# Tivoli MFG Ltd.

## Service Bulletin

Ride Type: Spin Out  
Date: September 8, 1998

Figure 2

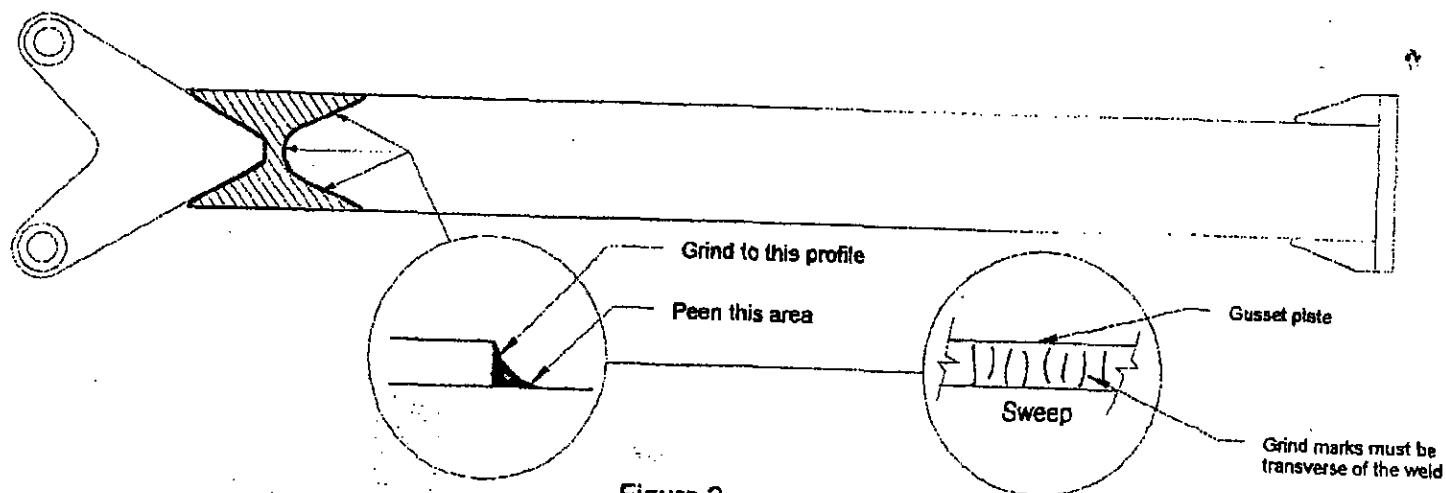
- Step 10: Grind weld on vehicle side of gusset as described in figure 2 drawing SOSA010C. Grinding must be transverse of the weld axis.
- Step 11: Peen weld with blunt instrument at the toe of the weld on top flat part of sweep as described in figure 2 drawing SOSA010C.

SOSA010E

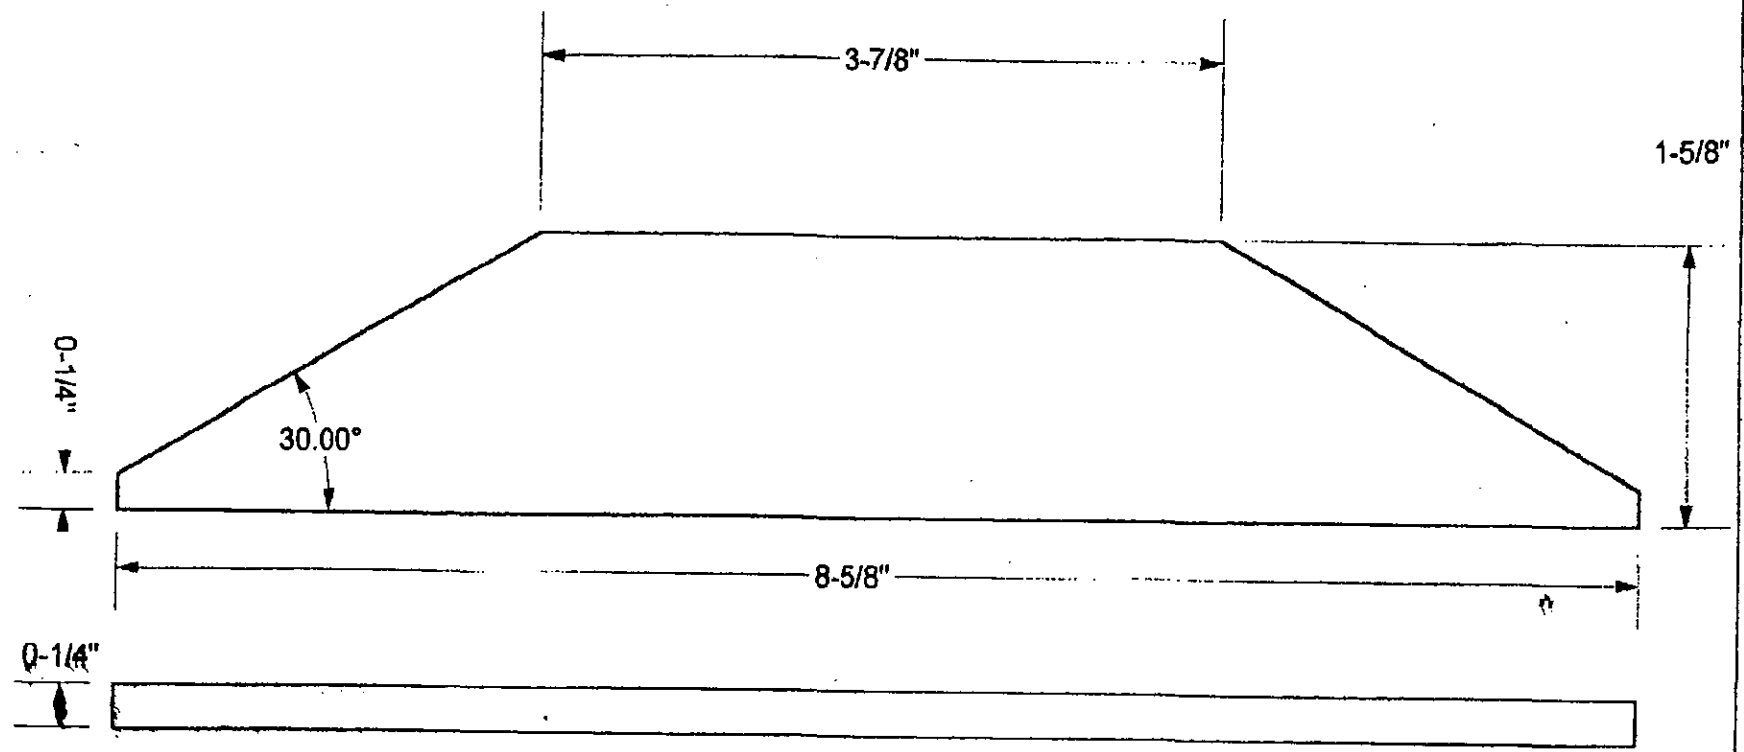
- Step 19: Taper weld from side point of top plate to side gusset as described in figure 1 drawing SOSA010E.
- Step 20: Taper weld at end of side gusset as described in figure 2 drawing SOSA010E.
- Step 21: Dress and sand all welds.
- Step 22: After all work is completed, paint sweeps, reassemble ride and completely inspect and test as outlined in the operators manual before opening to public.

Figure A

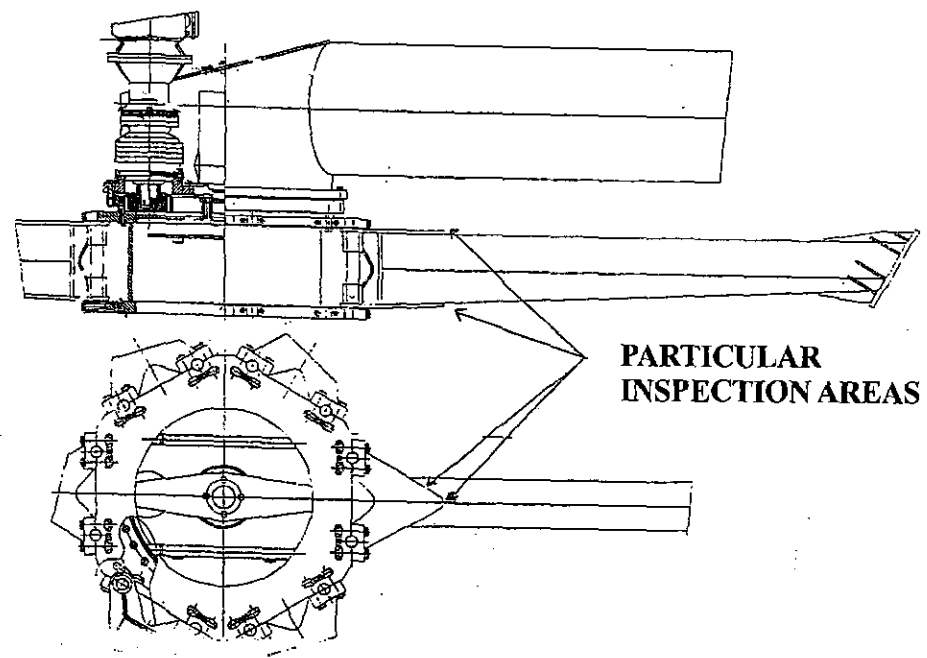
2. Immediately inspect all welds on the "Spin Out" sweep arms as indicated on the attached drawings. Be sure to visually inspect the full sweep length, and make appropriate repairs if necessary. Pay particular attention to the hinge plate gussets and the gussets and the tips of the gusset kits (Drawing A).

**Figure B**

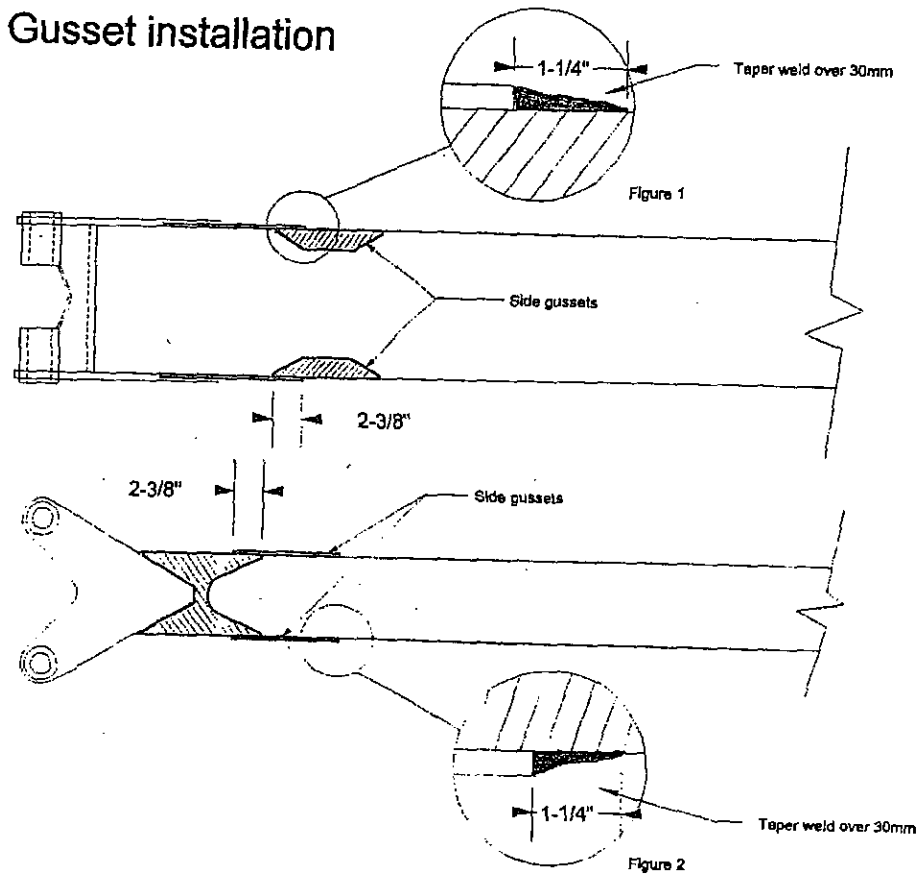
5. Inspect the gusset welds every 200 hours of operation or 6 months, whichever comes first with particular attention to the tips of the gusset kit as indicated in the attached drawing. (Drawing B). These inspections shall be performed by a certified inspector, with written documentation of that inspection maintained by the ride owner/operator.

Description	Part	Safety/pre installation.	Drawing#	Date
Spin Out Sweep Arm Pin			SOSA014A	12-10-04

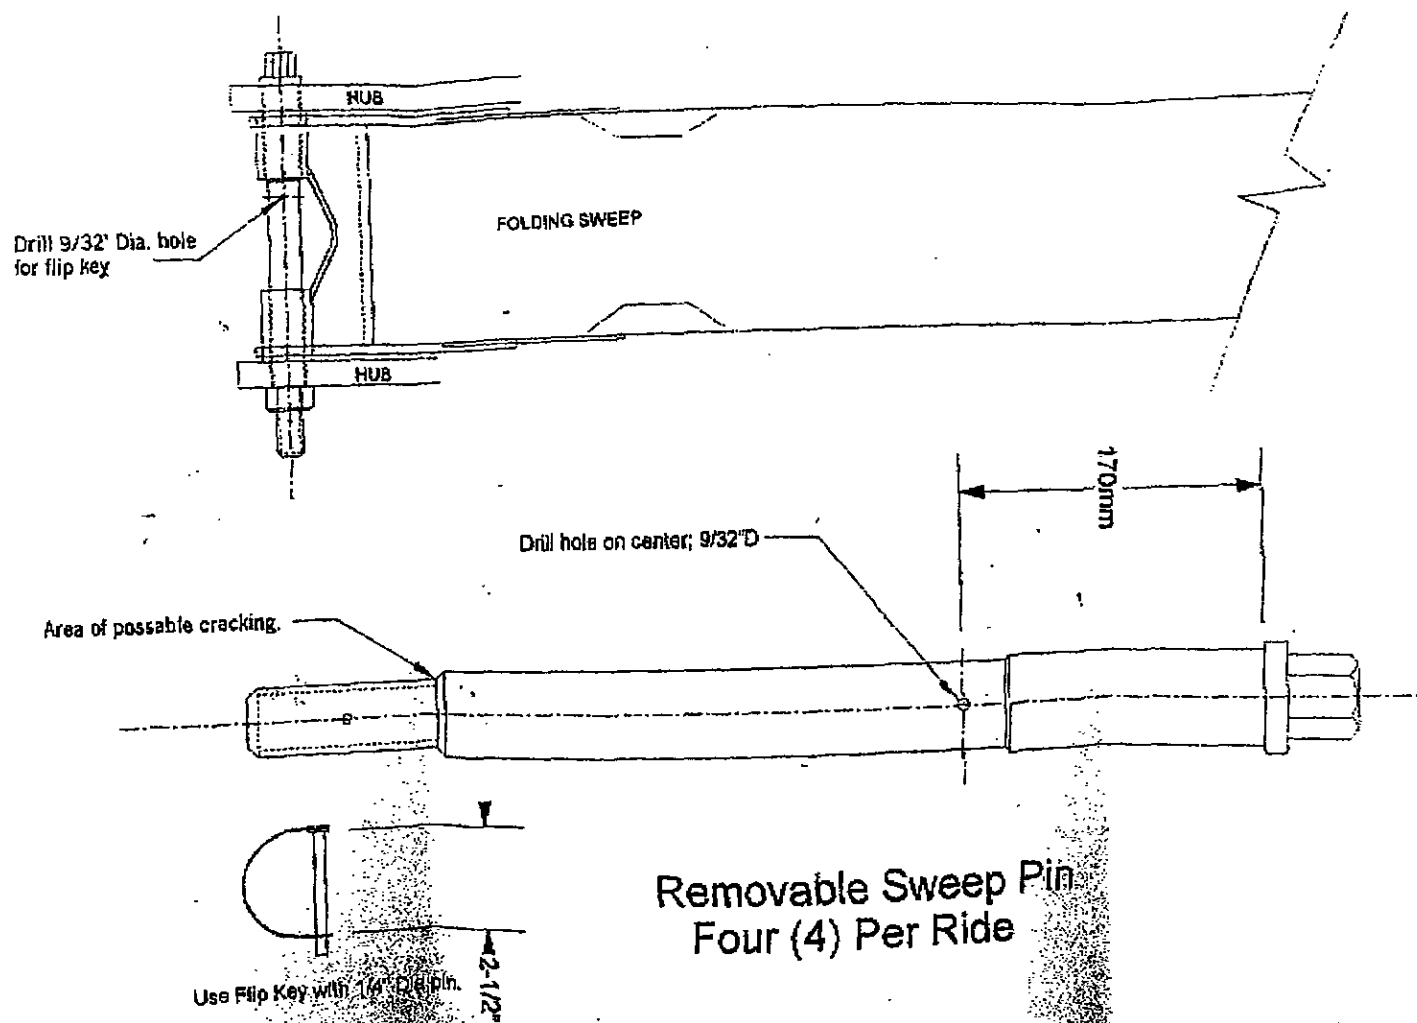
It has come to the attention of Tivoli Mfg. Ltd. that severe sweep pin bushing wear or abuse of removable sweep pins can cause these pins to crack or possibly break at the point where the threaded portion of the pin meets the shaft (see attached drawing SOSA014A for location). Even though there is an annual NDT requirement on these pins (Safety Bulletin SOSA009) Tivoli now requires the addition of a safety key to insure this pin remains in place in the remote case of pin breakage.

As illustrated on the attached drawing a 9/32" hole is to be drilled in the center of the 4 removable pins, 170mm from the underside of the head of the pin. The hole is to be deburred to remove any sharp edges.

During ride operation a 1/4" x 2- 1/2" Flip Key, as described in accompanied drawing, must be inserted through the hole and clipped in place. The key presently being inserted in the threaded area of the pin is still required.
